Proposal 12: 2195-03-70, WISC 20180 009
West Wells Street, City of Milwaukee
Milwaukee River Bridge B-40-544
USH 18
Milwaukee County

This is Addendum No. 04, which provides for the following:

ADDENDUM NO. 04

2195-03-70

ESTIMATED BRIDGE QUANTITIES / DESIGN DATA

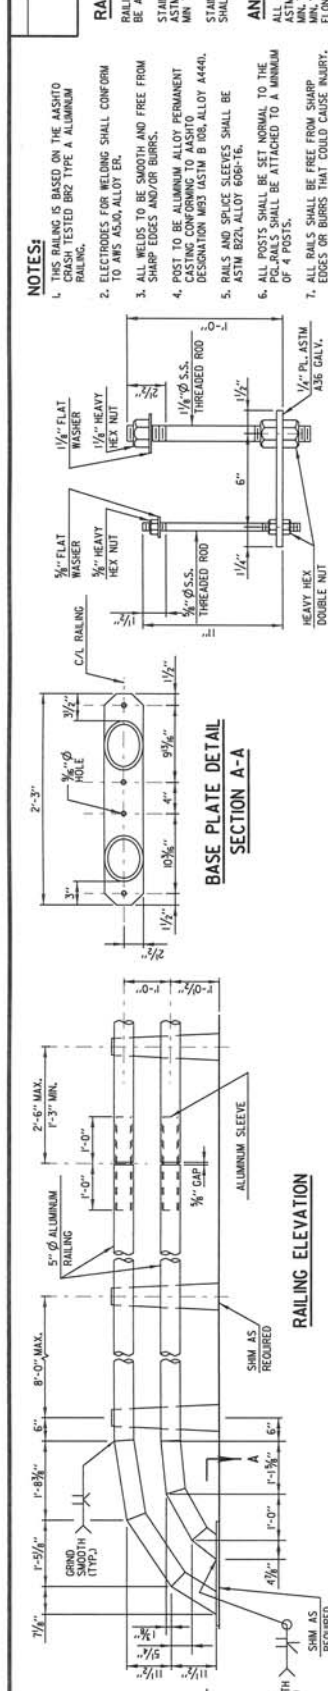
Revised Plan Sheets	
Plan Sheet	Plan Sheet Title (brief description of changes to sheet)
81	Estimated Bridge Quantities/Design Data (Bid Item Change)
135	2 Line Aluminum Railing Details (Updated Notes)

NO.	DATE	BY	REVISION
1	12/10/17	WCD	BO ITEM CHANGE

516-0500	RUBBERIZED MEMBRANE WATERPROOFING	SY	5		6				11
517-0000	PAINTING EPOXY SYSTEM B-40-544	LS							1
517-0000.S	PREPARATION AND COATING OF TOP FLANGES B-40-544	LS							1
517-1010.S	CONCRETE STAINING B-40-544	SF	335	1,800	2,020	436	280	202	5,373
517-1800.S	STRUCTURE OVERPAINTING RECYCLED ABRASIVE B-40-544	LS							1
517-1800.S	STRUCTURE OVERPAINTING CLEANING AND PRIMING B-40-544	LS							1
517-3000.S	NEGATIVE PRESSURE CONTAINMENT AND COLLECTION OF WASTE MATERIALS B-40-544	LS							1
517-6001	PORTABLE DECONTAMINATION FACILITY	EA							1
652-0210	CONDUIT RIGID NONMETALLIC SCHEDULE 40 1-INCH	LF					70	139	209
652-0220	CONDUIT RIGID NONMETALLIC SCHEDULE 40 1 1/2-INCH	LF					70	28	98
652-0225	CONDUIT RIGID NONMETALLIC SCHEDULE 40 2-INCH	LF					112	59	171
652-0230	CONDUIT RIGID NONMETALLIC SCHEDULE 40 2 1/2-INCH	LF					5	5	5
652-6006	ANCHOR ASSEMBLIES, LIGHT PILES, AND STRUCTURES	EACH					8	5	13
SPV.0025.501	CONCRETE SURFACE REPAIR AT RAILING POST	SF					45	50	95

STATE OF WISCONSIN DEPARTMENT OF TRANSPORTATION
STRUCTURE B-40-544
DRAWN BY: G.L.R. / C.B.B. / J.S.L. / B.S.L.
SHEET 57 OF 58
2 LINE ALUMINUM RAILING DETAILS
135

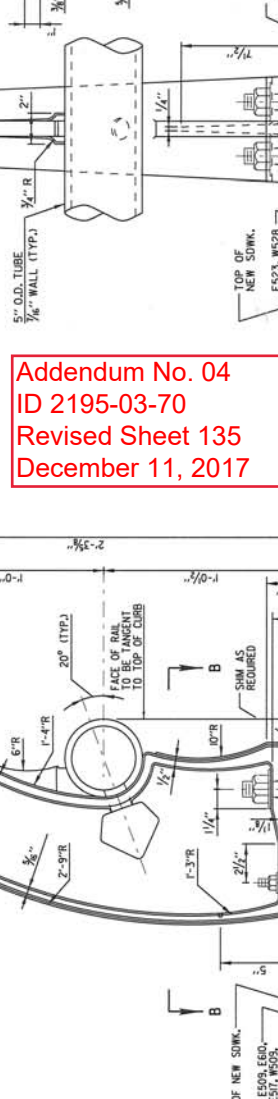
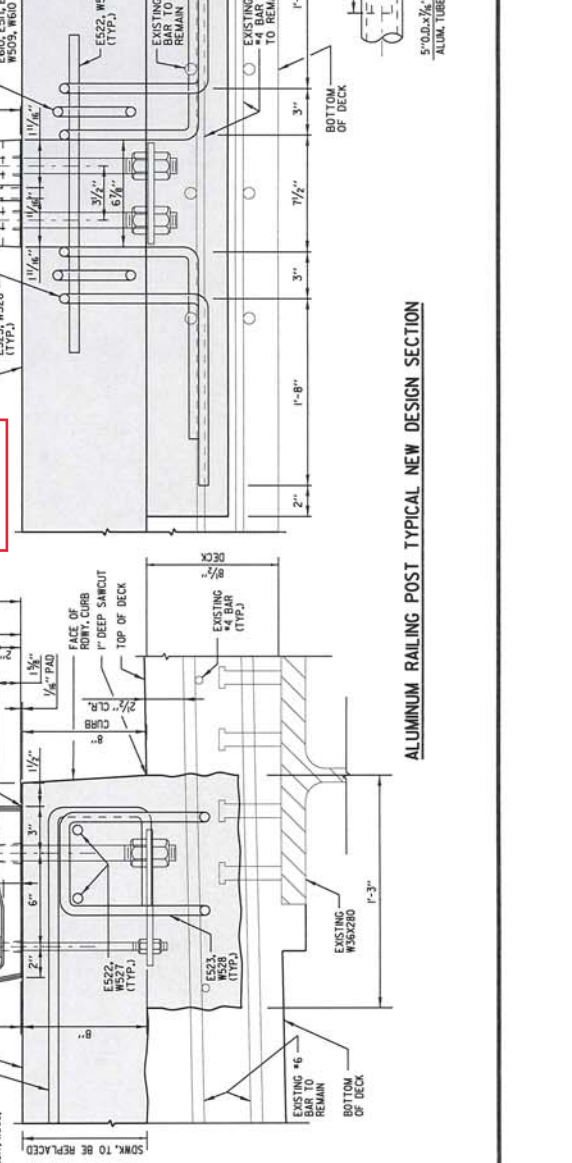
NO.	DATE	REVISION	BY
1		REVISED	DLT

- THIS RAILING IS BASED ON THE ASHTO CRASH TESTED BR2 TYPE A ALUMINUM RAILING.
- ELECTRODES FOR WELDING SHALL CONFORM TO AWS A5.10 ALLOY ER.
- ALL WELDS TO BE SMOOTH AND FREE FROM SHARP EDGES AND/OR BURRS.
- POSTS TO BE ALUMINUM ALLOY PERMANENT FINISH. FINISH TO MATCH RAILING. DESIGNATION W65 L6M 1/2 ALLOY A444.
- RAILS AND SPICE SLEEVES SHALL BE ASTM B221 ALLOY 6061-T6.
- ALL POSTS SHALL BE SET NORMAL TO THE MINIMUM PG. WALLS SHALL BE ATTACHED TO A MINIMUM OF 4 POSTS.
- ALL RAILS SHALL BE FREE FROM SHARP EDGES OR BURRS THAT COULD CAUSE INJURY.
- HOLE FOR BOLTS IN RAILS ARE TO BE FIELD DRILLED TO INSURE PROPER FIT.
- ALL HEAVY HEX NUTS AND WASHERS SHALL BE STAINLESS STEEL UNLQ.
- NEOPRENE PADS SHALL HAVE A NOMINAL DIAMETER THICKNESS OF 60 ± 1.5
- SHM MATERIAL SHALL BE ASTM B209, ALLOY 1000-O.
